Technical Service Bulletin

NUMBER: 22-005-01

Wheel Cover Rattle - 15" Steel Wheels

2000 - 2001 (PL) Neon

FIGURE 1 - WHEEL COVER

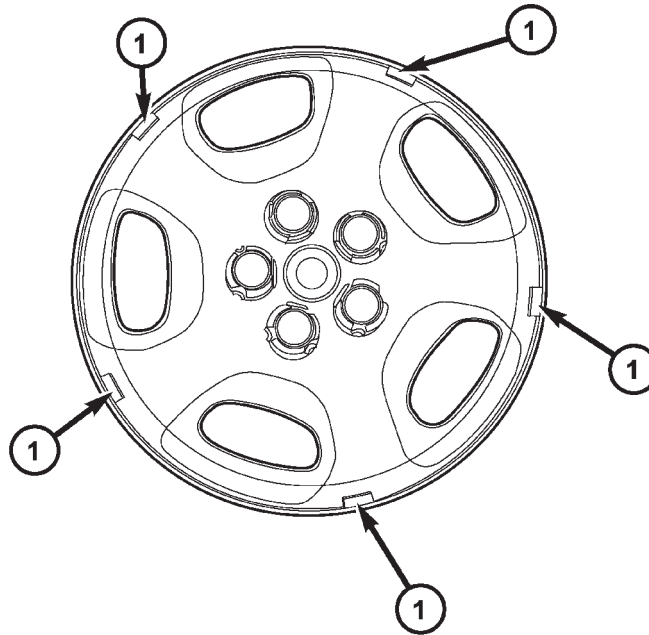
This bulletin involves the addition of 5 foam pads to each wheel cover.

Rattle noise coming from the wheel cover over bumps.

1. Clean the inside surface of the wheel cover where the foam pad will be installed using the Mopar Brake Parts Cleaner.
2. Wipe the cleaner off and allow the wheel cover to dry thoroughly.
3. Remove the backing paper from a foam pad and apply to in the center of one wheel spoke. Repeat the process until all five foam pads have been installed. (Figure 1)
4. Repeat the procedure for the remaining three wheel covers.
5. Install the four wheel covers onto the vehicle and torque nuts to 25 in.lbs.

1-	FOAM PADS
----	-----------
